Addendum 100 – UN Regulation No. 101

Revision 3 - Amendment 10

Supplement 11 to the 01 series of amendments – Date of entry into force: 22 June 2022

Uniform provisions concerning the approval of passenger cars powered by an internal combustion engine only, or powered by a hybrid electric power train with regard to the measurement of the emission of carbon dioxide and fuel consumption and/or the measurement of electric energy consumption and electric range, and of categories M₁ and N₁ vehicles powered by an electric power train only with regard to the measurement of electric energy consumption and electric range

Figure 1
 NEDC test cycle

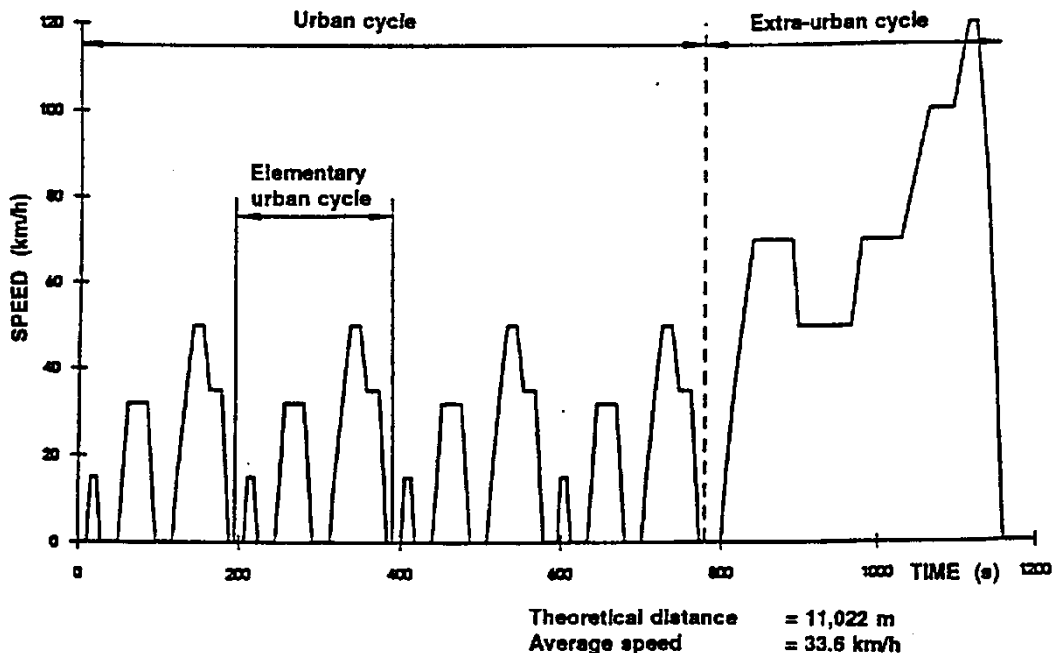
Paragraphs 1., 1.1., 1.2. and 1.3., renumber as paragraphs 2., 2.1., 2.2. and 2.3. respectively and amend to read:

"2. NEDC test cycle

2.1. Composition

The NEDC test cycle is composed of two parts (see Figure 1):
